Our Ref: CW25146

**6 Dorchester Street, South Brisbane
RESPONSE TO INFORMATION REQUEST
(Application: 006914469)**

TITLE
CONCEPT STORMWATER
SKETCH

TITLE
CONCEPT EARTHWORKS
PLAN

Designed	JBM	Drawn	JBM	Date	08.05.26
Approved		Scale	AS SHOWN		
Drawing No.	CW25146-SK01				Rev.
					A

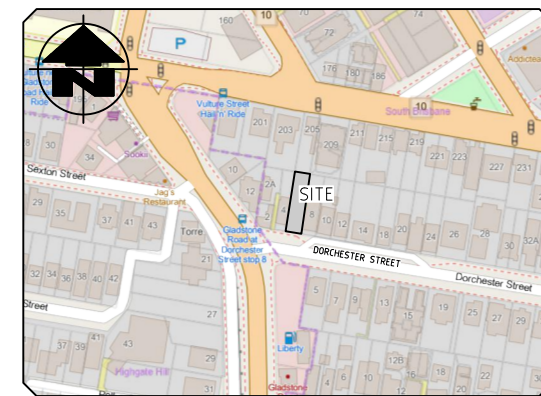
The application material has not addressed the prescribed secondary codes and in particular has not addressed the earthworks and retaining walls required for the proposal, or stormwater discharge for the site.

Provide an Engineering Report and drawings which discuss the engineering requirements for the proposal including earthworks, retaining walls and stormwater and address the relevant assessment benchmarks.

In response to Item 3, concept engineering sketches for the proposed earthworks and stormwater infrastructure have been prepared and are included within this submission. A Code Compliance assessment for Filling and Excavation has also been undertaken to demonstrate compliance with the relevant assessment benchmarks. Refer to the concept engineering sketches for more information.

PROPOSED STORMWATER PIT
AND ROOFWATER STUB
APPROX. IL 30.950.

EXISTING Ø150 STORMWATER
LINE TO BE REMOVED AND
LOWERED WITH NEW Ø225 uPVC

PROVIDE NEW
MANHOLE OVER
EXISTING
STORMWATER
PIPE.

CONNECT STORMWATER INTO EXISTING MANHOLE.
EXACT DEPTH OF MANHOLE TO BE CONFIRMED
PRIOR TO DETAILED DESIGN. FINAL PROPOSED
LEVELS TO BE CONFIRMED.
